Access Compliance Report Public Rights-of-Way (Curb Ramps)

Intersection ID: 21442Main Street:E_ARROWOOD_RDCross Street:GRAND_METIS_DRLocation:NEADA ID: 50B4F5BCEEE2Ramp Type:ParaDiagInitial Pass/Fail:FailOverall Compliance:NoSeverity Score:25

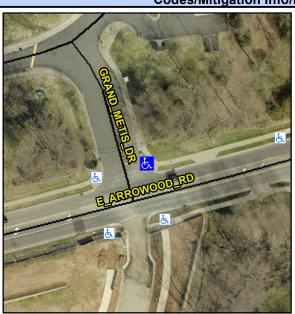
Compliance Description Data Compliance Description Data					
		Data		liance Description	Data
N/A	Ramp Length LT (in)	41.0	N/A	Ramp Length RT (in)	24.0
Yes	Ramp Width LT (in)	60.0	Yes	Ramp Width RT (in)	60.0
No	Ramp Slope LT (%)	18.3	No	Ramp Slope RT (%)	9.7
Yes	Ramp XSlope LT (%)	0.8	Yes	Ramp XSlope RT (%)	0.5
N/A	Landing Length (in)	N/A	N/A	DWS Provided?	N/A
N/A	Landing Width (in)	N/A	N/A	DWS Contrast?	N/A
N/A	Landing Slope (%)	N/A	N/A	DWS Length (in)	N/A
N/A	Landing X Slope (%)	N/A	N/A	DWS Full Width?	N/A
N/A	Landing Curb? (Y/N)	N/A	N/A	DWS Offset (in)	N/A
N/A	Shared Landing?	N/A			
N/A	Gutter Ponding?	N/A	N/A	Gutter Slope (%)	N/A
N/A	Gutter Lip Ht (in)	N/A	N/A	Gutter X Slope (%)	N/A
N/A	Painted X Walk1?	Yes	N/A	Painted X Walk2?	No
	X Walk 1 Direction	To SW		X Walk 2 Direction	To S
N/A	X Walk 1 Width (in)	53.0	N/A	X Walk 2 Width (in)	N/A
	X Walk 1 Slope (%)	6.9		X Walk 2 Slope (%)	4.3
	X Walk 1 X Slope (%)	5.8		X Walk 2 X Slope (%)	6.0

Remove & Replace Curb Ramp With Two New Directional Ramps or Equivalent.

R304.3.2
